Petition for Post-Certification Amendment

Sewer Interconnection Upgrades

Huntington Beach Energy Project

(12-AFC-02C)

PLOT PLAN
SCALE: 1/64"=1'-0"

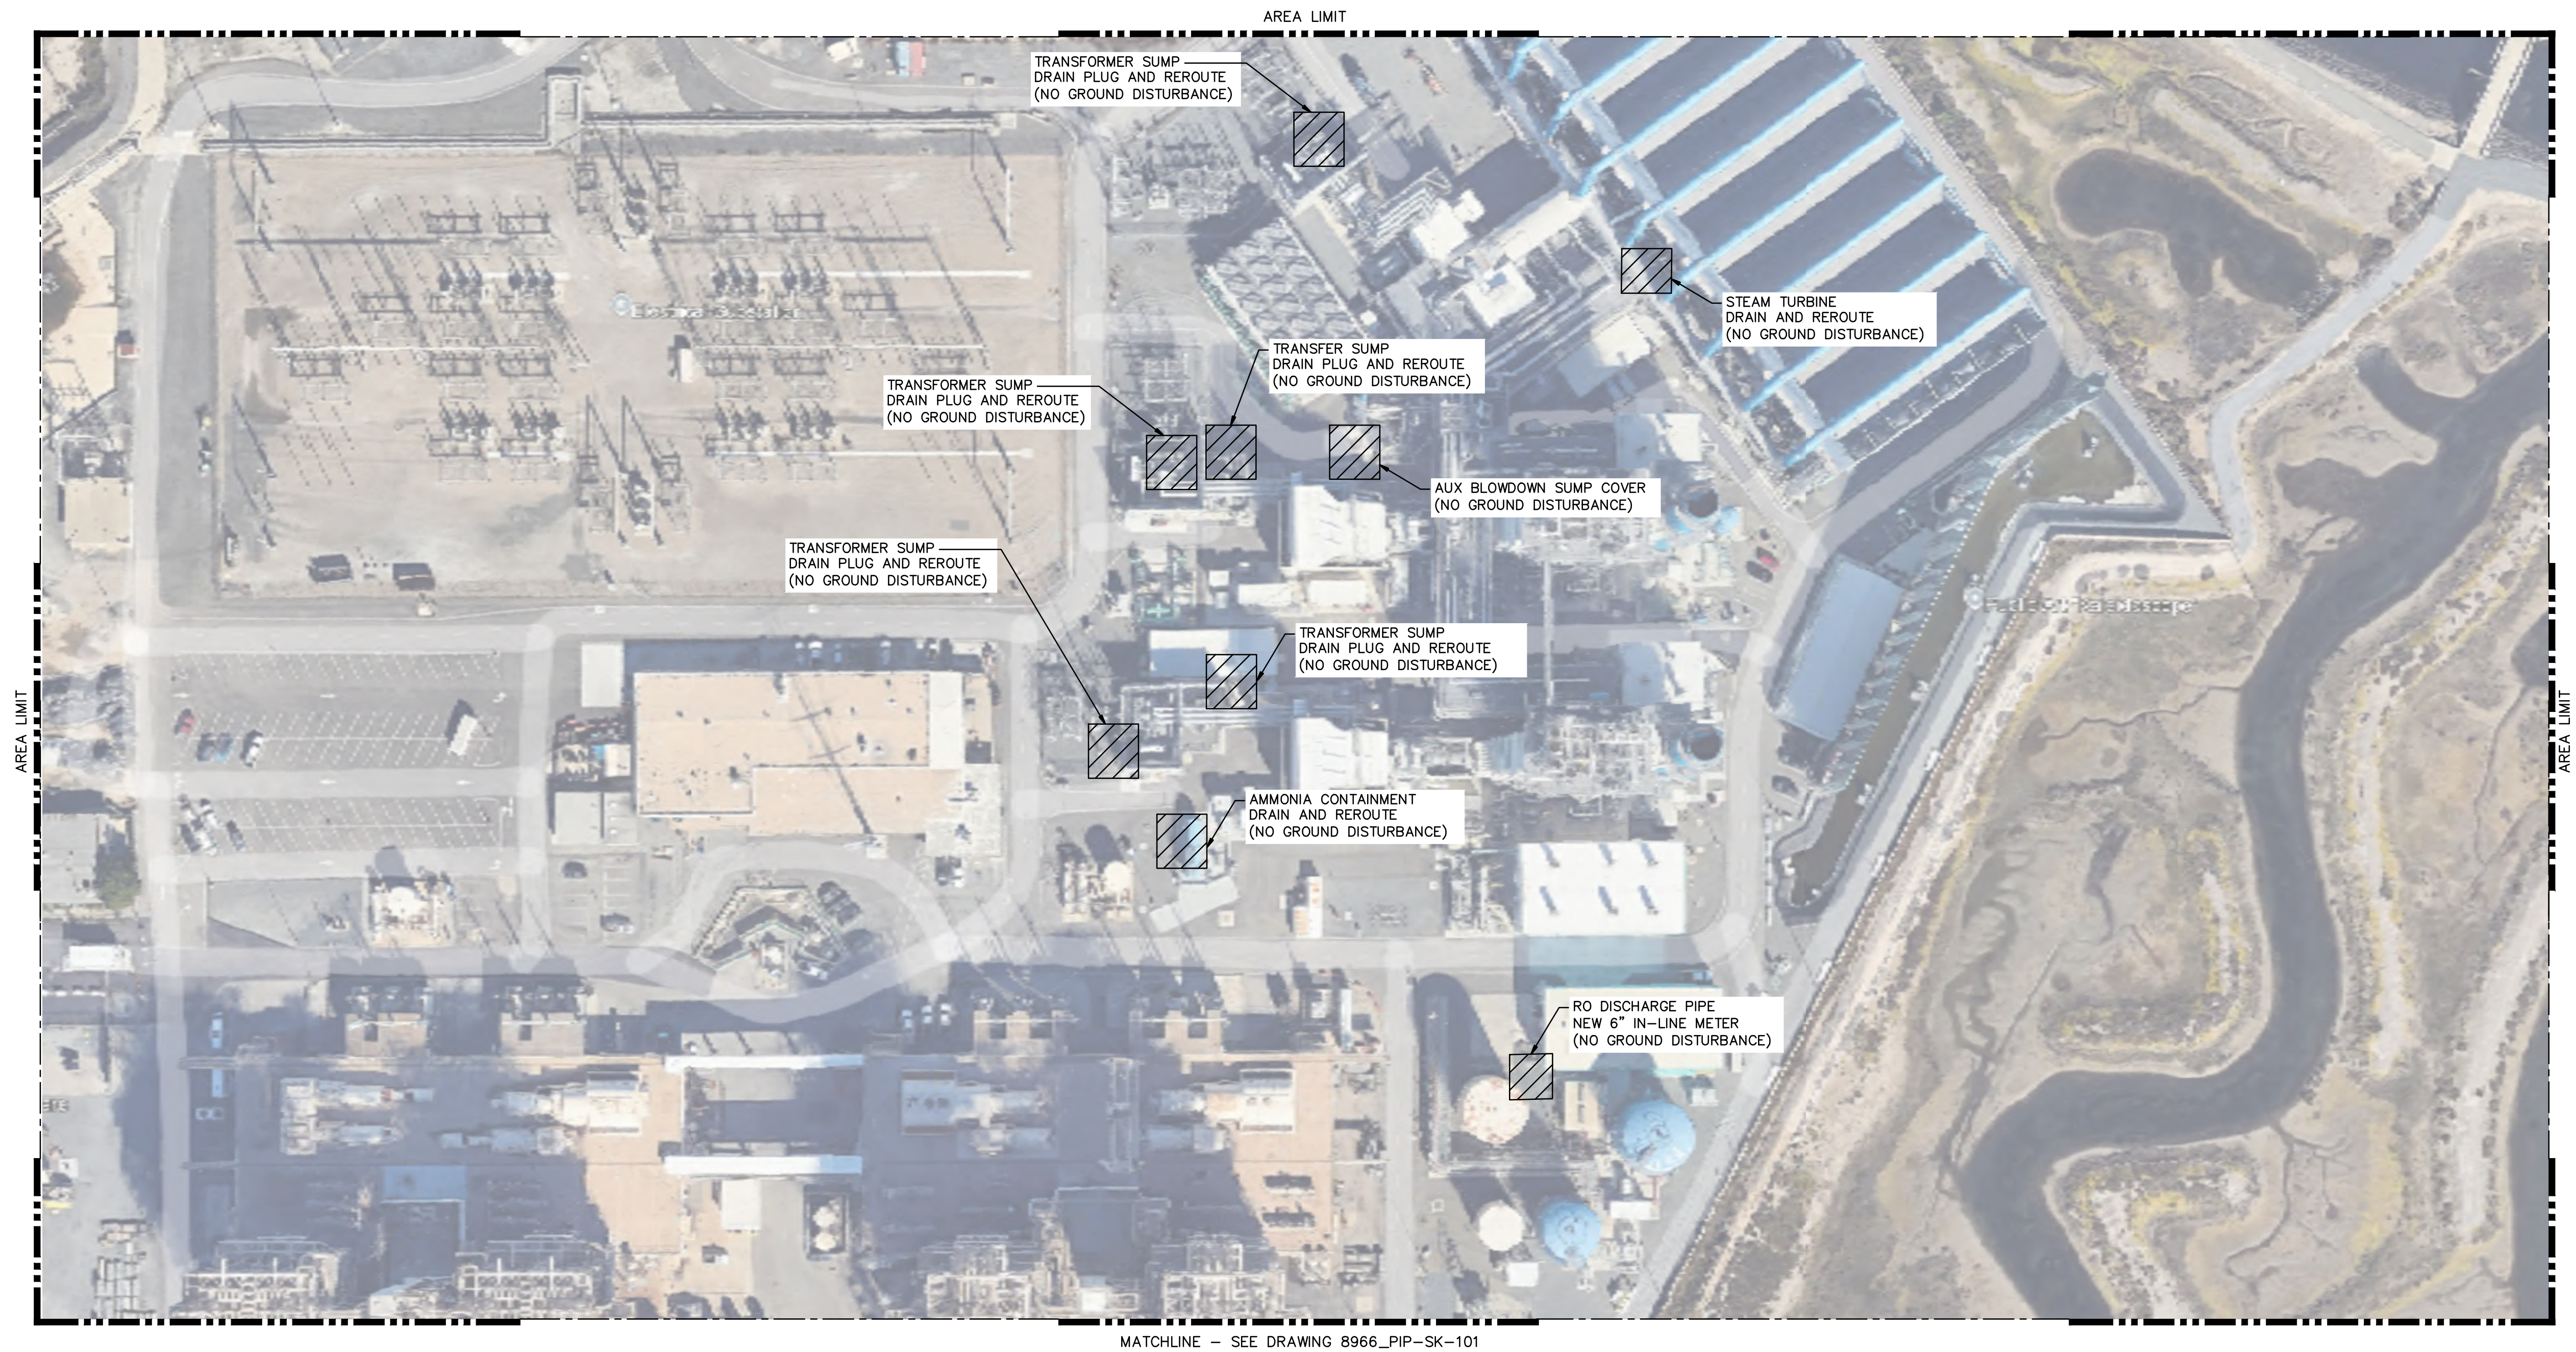
The project will involve construction of a new wastewater force main, wastewater pumping station, and a floating basin cover (to be installed on an existing basin). The force main will connect to an existing sewer lateral owned by AES at the southeast corner of the HBGS property. The project will also include piping modifications to exclude rainwater ingress into the wastewater system from the site's storm drain system, transformer containments, ammonia storage tank containment, and STG drains tank sump. Construction activities will not extend outside of the HBGS boundary. Attachment 2.1 includes the civil design drawings for the proposed sewage line construction.
